3625 E. Doverhill Drive

13-lot Planned Unit Development/Public Park/Preliminary Plat
SUB-22-005

Summary

Preliminary Park Design Concept

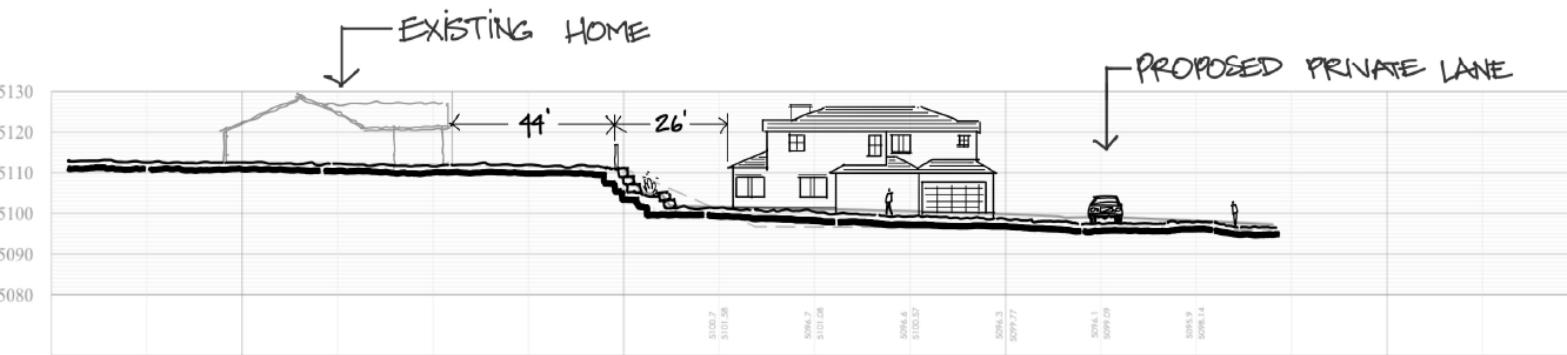
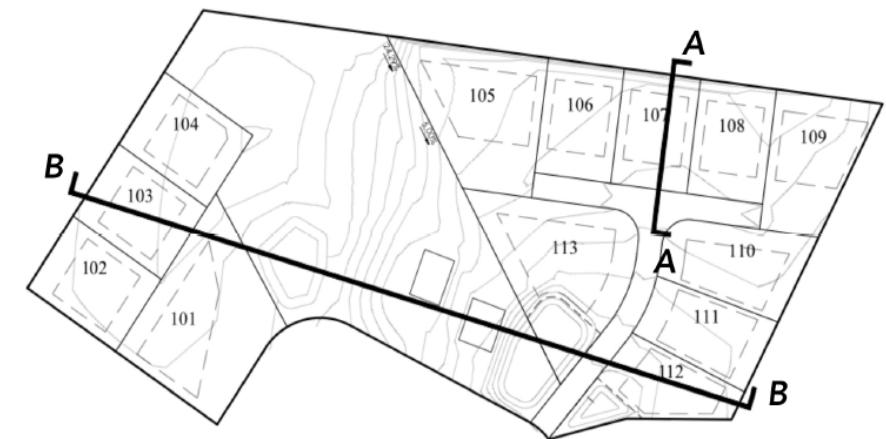
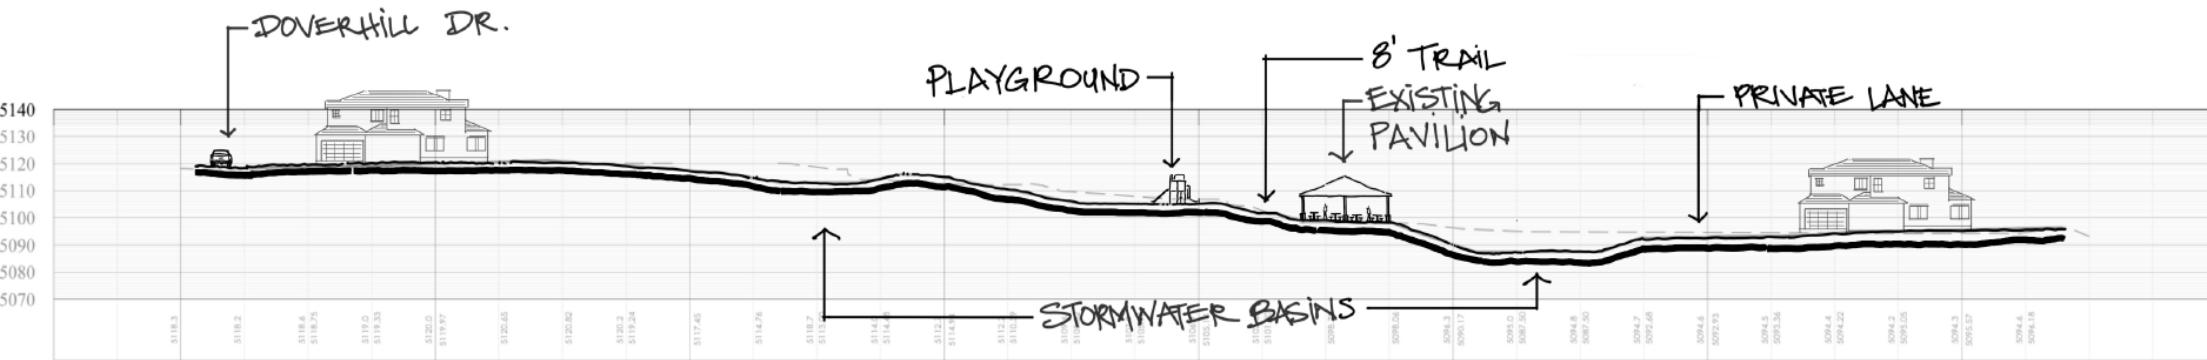
1. Lots 105-109 should be graded with the minimum amount of fill possible that still achieves site functionality.
2. Retaining wall tiers should be designed with planting beds between the levels.

3. Access along Street B should be extended to improve pedestrian connectivity to the park.
 - a. Add a sidewalk which extends access along Street B into the park, westward.

- b. Provide an easement which allows for future pedestrian access to Wasatch Blvd., eastward, while still allowing Lot 109's owners to landscape their front yard.

4. Minimize the crowding between homes on lots 110, 111, and 112 by articulating buildings to maximize the sites in different directions.
5. Animate the park by closing the walking loop internally within the park.

6. Augment the playground with more amenities for young children, including swings and "tot lot" equipment.
 - a. Sink the playground equipment into the grade to match that of the pavilion. **Contact Scott Peters, ARC Chair, with questions.**

7. Reduce neighborhood bifurcation by eliminating dedicated parking spaces, in favor of on-street parking instead.
 - a. If off-street parking is required, minimize the number of stalls on Doverhill Drive to provide clearer visibility into the park.

- b. Improve the pedestrian access from Doverhill into the park area by making the walking path more clear and easily accessed.
- 8. Minimize the slope of the retention basin to keep it as shallow as possible.

- a. Contour the shape to make this space feel more natural rather than crater-like.
 - b. Maximize the amount of retention safely done on lots to limit the amount needed in the pond.

- c. Provide a greater buffer between the pavilion and the pond, so that pavilion users aren't tipping right into the pond.
 - d. Loop the walking path around the pavilion.

- e. Landscape the pond in sod to encourage use.
- 9. Add seating and shade trees around the playground, which provide direct shade to the equipment.
- 10. Maintain lighting to the pavilion, if feasible.

- a. Articulate required street lighting to benefit the park.
- 11. Include 1-2 pet waste stations along the walking loop.
- 12. Utilize low-water species that are also pollinator-friendly in landscaping.
